1 **Q. Mr. Schlissel, please state your name, position and business address.**

21 A. Synapse was asked by CUB to review Wisconsin Public Service Corporation's  
22 request for a Certificate of Public Convenience and Necessity ("CPCN") for the  
23 proposed Weston Unit 4 power plant, focusing in particular on the EGEAS  
24 analyses performed by WPS and the PSCW Staff.

**Figure SK-1: WPS Projected DSM Savings**

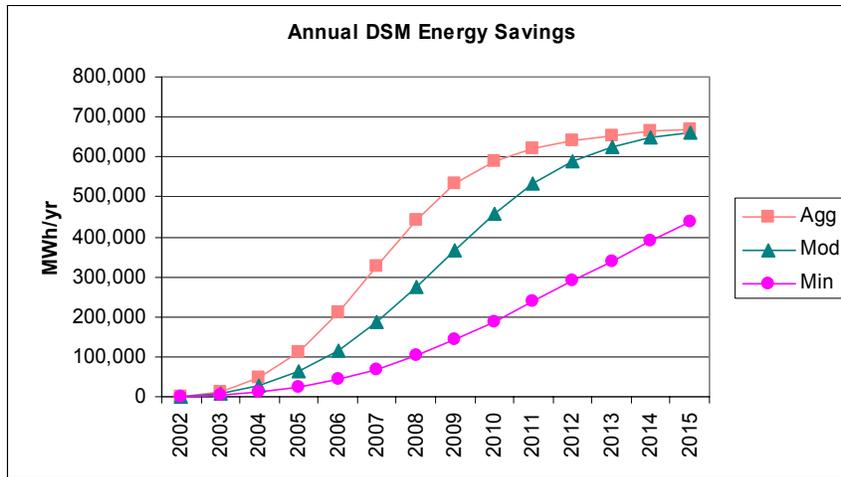
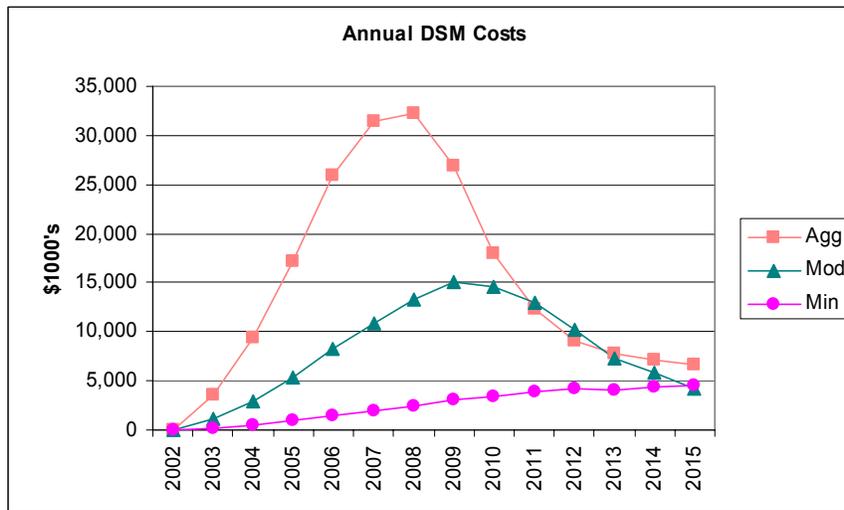
19 A. Yes. The DSM programs as used by WPS in its EGEAS analyses are oddly  
20 designed. For example, as shown in Figures SK-1 and SK-2, the Moderate and the  
21 Very Aggressive DSM programs produce nearly the same energy savings by the  
22 final program year of 2015. However, the Very Aggressive program is much  
23 more expensive.

24 This appears to be because WPS's Very Aggressive DSM program spends a lot of  
25 money (apparently not very efficiently) in the early years and then declines  
26 rapidly. A better designed program would increase DSM expenditures over time,  
27 but at a more gradual rate, in order to achieve a larger, but more cost-effective,  
28 level of energy savings.

**Figure SK-3: Results of PSCW Staff EGEAS Scenarios**

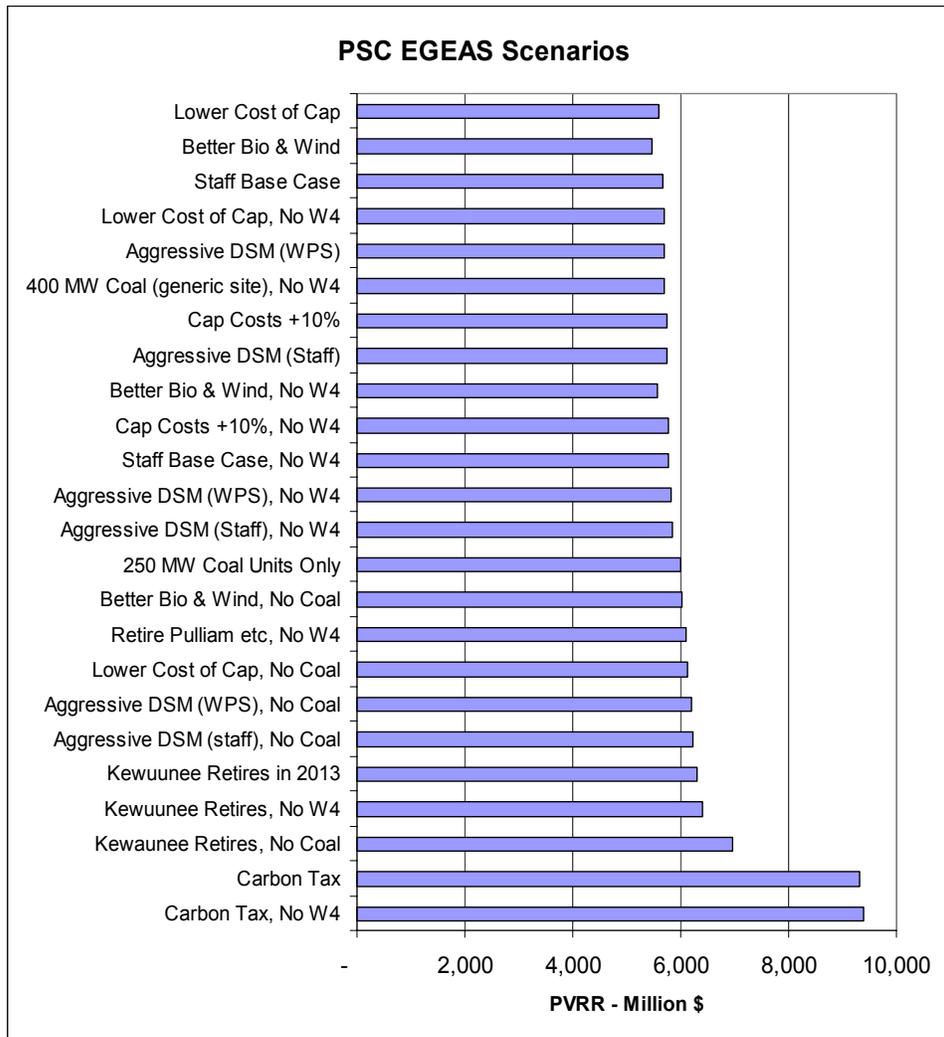
6 **Q. Do the results of many of the PSCW Staff EGEAS runs have relatively close**  
7 **present value revenue requirements?**

8 **A. Yes. This is shown in Figure SK-3 below.**

4 A. No. The results of the comparisons presented in Table SK-1 show that there are  
5 credible scenarios in which plans without Weston 4 would have PVRR reasonably  
6 close to the PVRR of PSCW Staff's optimal base case and the scenario in which  
7 the cost of Weston 4 is ten percent higher than currently forecast. However, we  
8 do not believe that the Commission should reject WPS's application for a CPCN  
9 solely on the basis of these results or on the weaknesses we have found in WPS's  
10 EGEAS modeling. Instead, we believe that the PSCW Staff should rerun its  
11 EGEAS analyses reflecting the following assumptions:

**Figure SK-4: WPS Fuel Mix Based on MWH Generation**

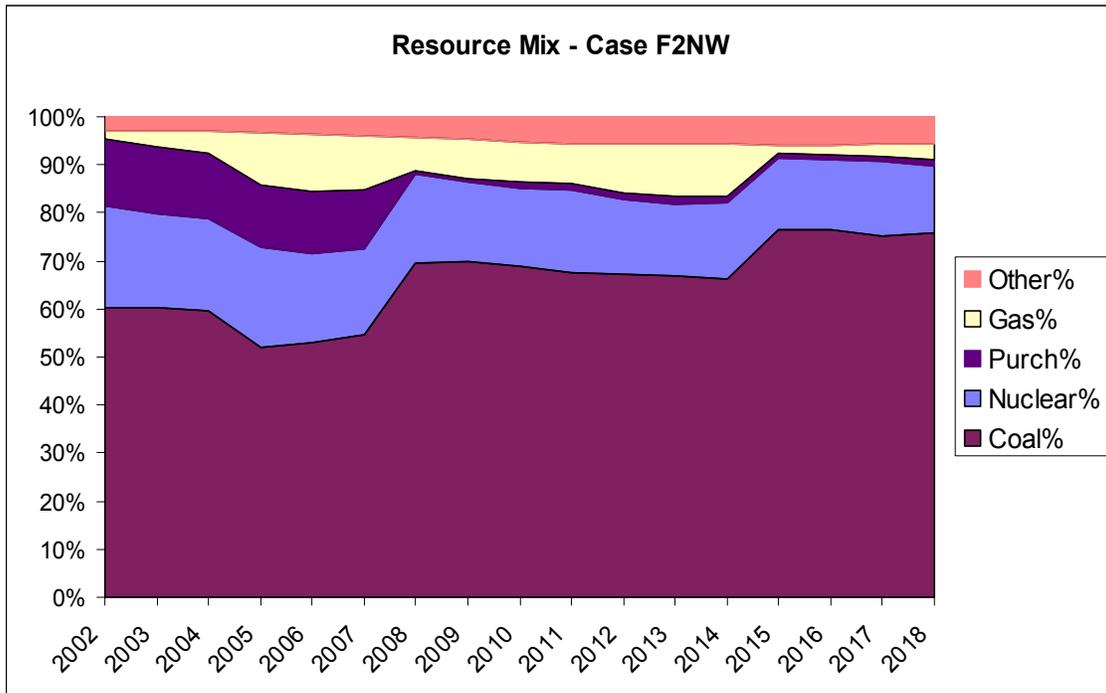
21          The effect of adding Weston 4 is even more pronounced if we consider the  
22          percentage of the Company's total energy that would be generated by coal-fired  
23          units. For example, as shown in Figure SK-4 below, under WPS Plan F2NW the  
24          percentage of WPS's electricity that was generated at coal-fired facilities would  
25          increase from approximately 63 percent in 2002 to about 70 percent in 2018.

5 A. This increasing reliance on electricity from coal-fired generating units leaves  
6 WPS's ratepayers exposed to the substantial risk of CO<sub>2</sub> taxes or regulations or  
7 coal industry events that could dramatically raise the price of the electricity from  
8 these facilities. At the same time, air emissions can be expected to be  
9 significantly higher than they would be under alternative plans that included  
10 substantial amounts of DSM and wind capacity, as well as some smaller coal  
11 and/or natural gas-fired generating units.
